# TRANSFER THE TRANSMISSION JACK

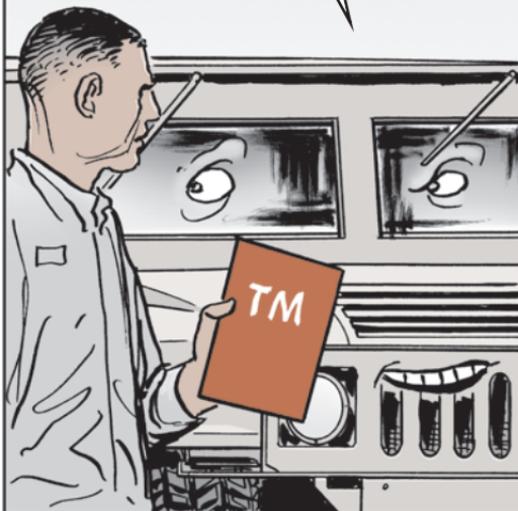
WELL, *DON'T* USE THE PROCEDURE IN *THAT* TM TO INSTALL THE JACK!

Word from the field is that the Gray model MM-2000 transmission jack, NSN 4910-00-585-3622, can't be installed correctly from the side of the vehicle shown in the drawing in Task 7-6 on Page 7-11 of TM 9-2320-280-34 (Jan 96, w/Ch 2, Jul 04). So TACOM LCMC plans to make this clear in a future update to this TM and TM 9-2320-387-24-2.

The transmission jack should only be installed inline with the transmission, **not** at a 90° angle to the transmission. The open front of the jack should face the front of the vehicle. This allows a support to be placed near the rear of the engine. It also allows you to properly install the transmission on the jack.
